**To:** Kristopher Byrd, Well Construction Manager  
**From:** Tommy Laird, Well Construction Program Coordinator  
**Subject:** Review of Water Right Application G-18760  
**Date:** May 29, 2024

# Groundwater Application Review Summary Form

Application # G- 18760

TO: Water Rights Section Date 8/11/2023  
 FROM: Groundwater Section Grayson Fish  
 Reviewer's Name  
 SUBJECT: Application G- 18760 Supersedes review of 6/15/2020  
 Date of Review(s)

### This Distance-Drawdown

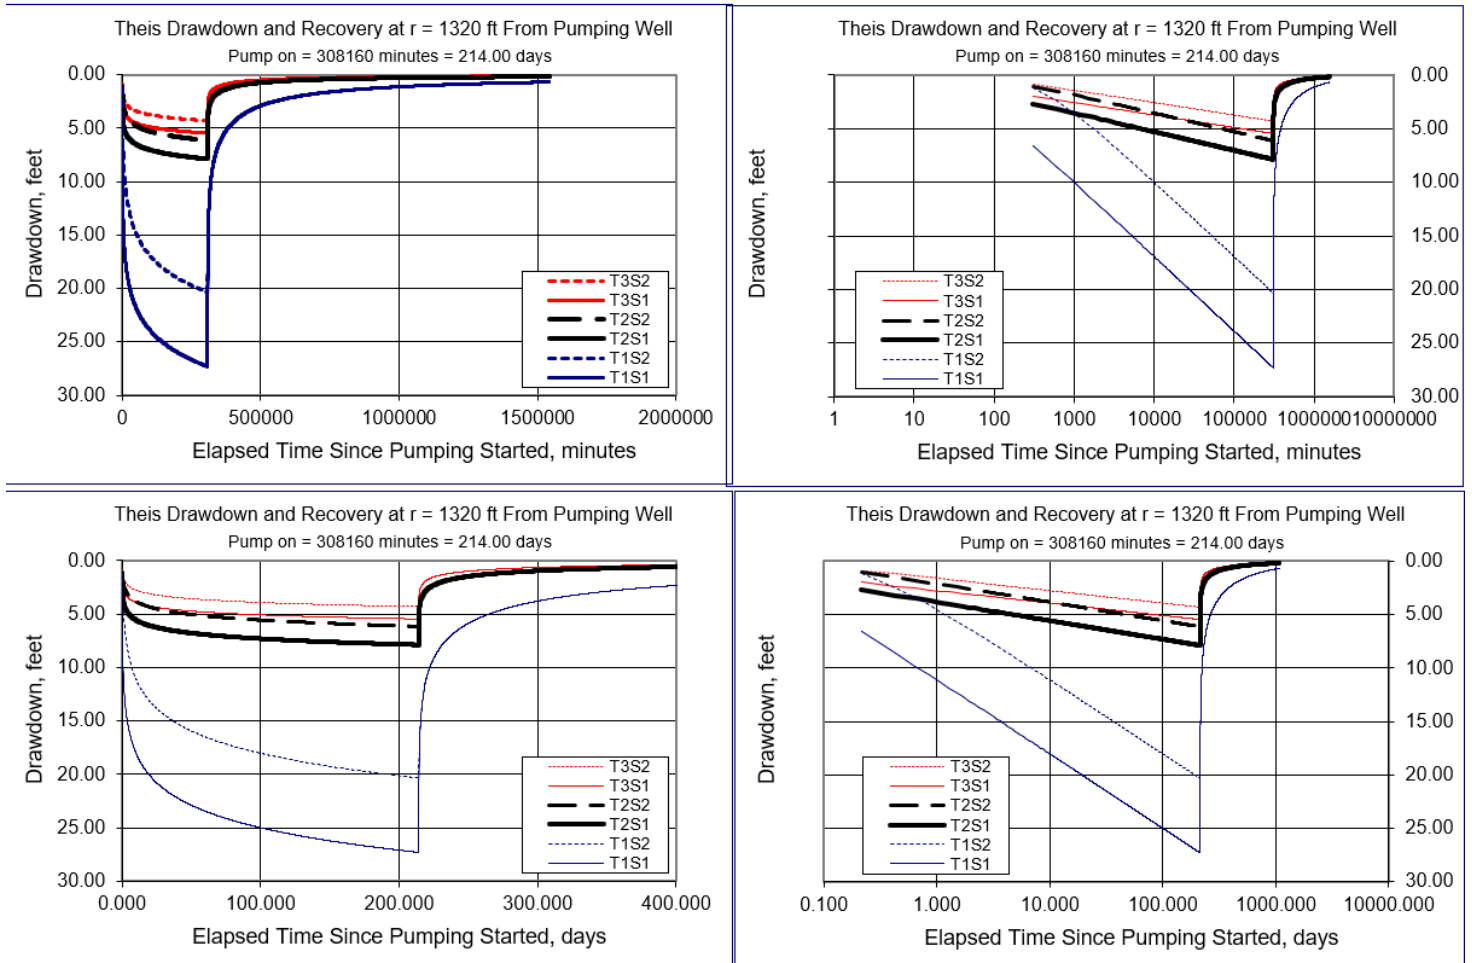
- B3. **Groundwater availability remarks:** The proposed well would produce water from “predominantly basalt layers” which would mean the well would likely extend to a depth deeper than 200’. The well log of KLAM 58670 drilled approximately 1 mile away at a similar elevation of the proposed well encountered water bearing “grey basalt & red cinder” starting at 179’ bls and a static water level of 5’ bls. Static water levels in any given well appears to be controlled by topography and is close to surface water elevation. Groundwater level data is limited in the area, however, KLAM 10521 is located approximately ¼-mile southwest of the POA and groundwater levels in that well have not excessively declined or shown an excessively declining trend. Therefore, a preponderance of evidence does not exist to say that groundwater is over-appropriated. The applicant’s proposed well is located within 1 mile of a densely-developed neighborhood (several 1-acre lots) where most of the tax lots that have been developed have a domestic well associated with them (nearly 40 wells have been drilled in the Section which are concentrated in the southern part near the proposed POA). Approximately 20 tax lots are within ¼ mile of the proposed POA. Many of the well logs for this area report total well depths around 100 to 150 feet and SWLs between 20 and 70 ft (the range of SWLs are more likely controlled by land surface elevation and not vertical changes in hydrogeologic characteristics). A Theis distance drawdown model along with the newly proposed rate of 1.32 cfs as listed in the proposed mitigation plan was used to estimate the magnitude of well-to-well interference that may result from the proposed uses (Theis). Drawdown from the proposed use at neighborhood wells within ¼ mile may be over 5 feet by the end of the irrigation season. It should be noted that this is likely an overly conservative estimate as if the applicant was to exercise their full requested rate of 1.32 cfs they would fulfil their proposed duty of 317.13 ac/ft in 121 days, almost half the expected irrigation season. Regardless, even at the fully requested rate for the entirety of the irrigation season, a preponderance of evidence does not exist to determine injury is likely to occur. Permit conditions should be applied as referenced in B1(d)(i) of this form.

**Hunt Streamflow Depletion**

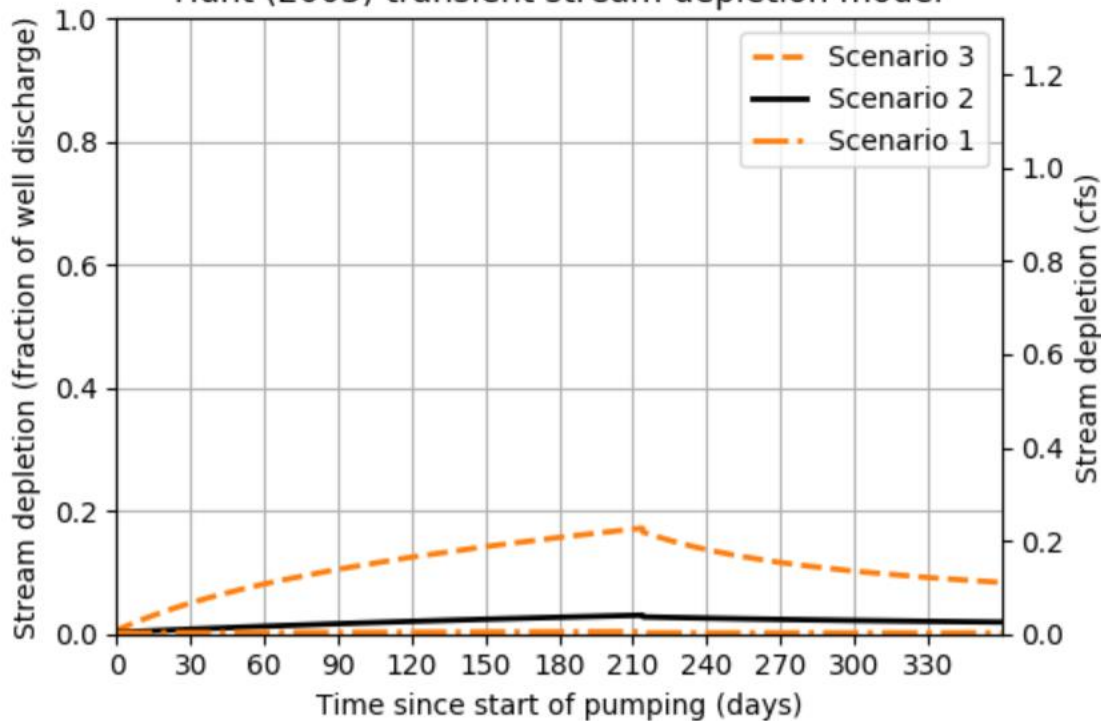
**Comments:** Instream Right KA 484 is located on Fourmile Cr. In the immediate vicinity and within 1 mile of the proposed POA and the proposed rate is greater than 1% of the instream water right.

Stream-depletion was estimated using the Hunt-2003 stream-depletion model using parameter values derived from aquifer tests in the area, extracted from Gannett et al., (2012), or representative of the geologic material in the vicinity of the proposed POA.

C6. **SW / GW Remarks and Conditions:** The applicant's proposed POA would be producing from an aquifer that has been found to be hydraulically connected to surface water – specifically Fourmile Creek at a distance of less than 1 mile. The proposed maximum rate of appropriation is less than 1% of the pertinent adopted perennial streamflow for the WAB but is greater than 1% of the adopted instream water right for Fourmile Creek. Per OAR 690-009-0040(4) the POA is assumed to have the Potential for Substantial Interference.
